CITY PLANNING COMMISSION

APPLICATION: Variance to waive the required six-foot high solid masonry wall between commercial and residential uses (Sec. 3-D-7-a)

LOCATION: 2009 'V' Street

APPLC. NO. P84-064

Masonry Wall
Required Along
Property Line

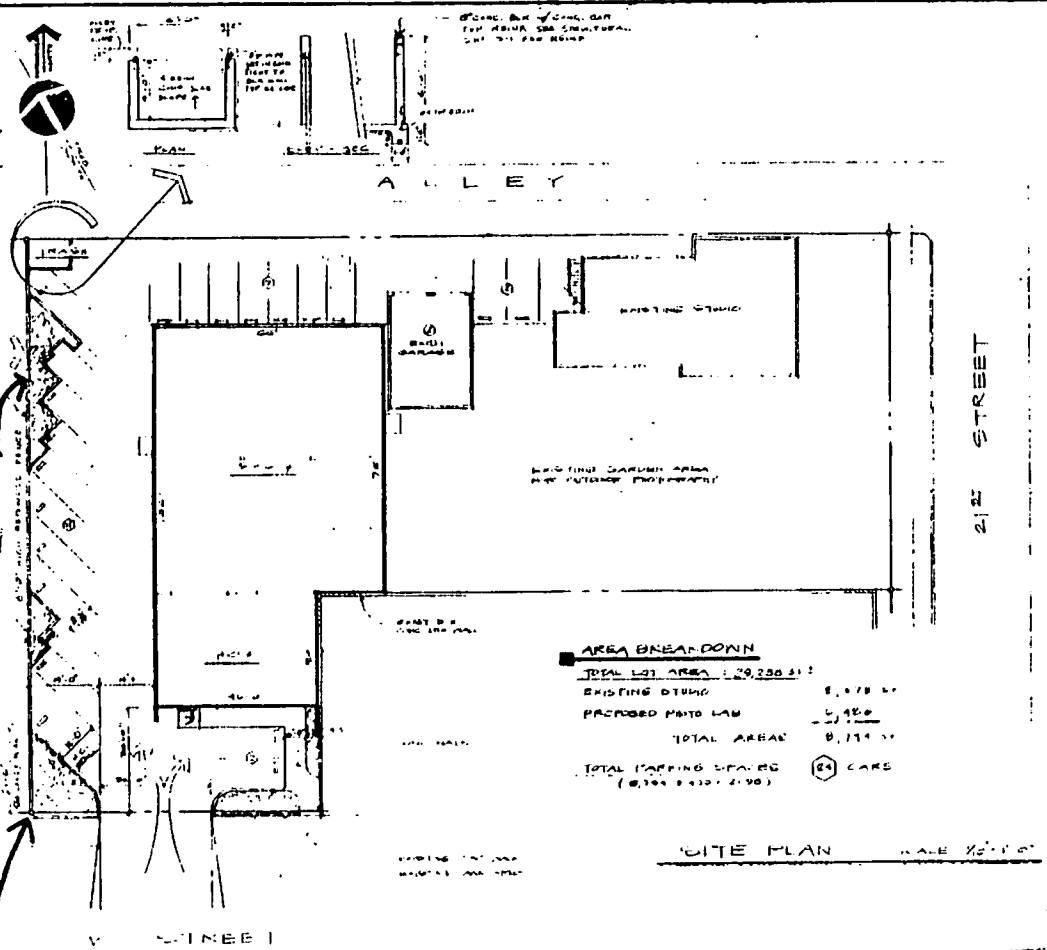
While the residences to the east of the site are across 21st Street, the single family residences to the west are directly adjacent to the site. The Zoning Ordinance requires that a six-foot high solid masonry wall be erected between commercial and residential uses. This requirement applies to the western property line of the site (Exhibit B). The applicant, however, has constructed a six-foot high redwood fence along this property line (Exhibits C and D), and is requesting a variance to waive the masonry wall requirement.

There is no hardship or unusual circumstance that would prevent the applicant from constructing a six-foot high solid masonry wall along the western property line. Therefore, staff recommends denial of the variance request.

STAFF RECOMMENDATION: Staff recommends denial of the variance to waive the required six-foot high solid masonry wall, based on Findings of Fact which follow:
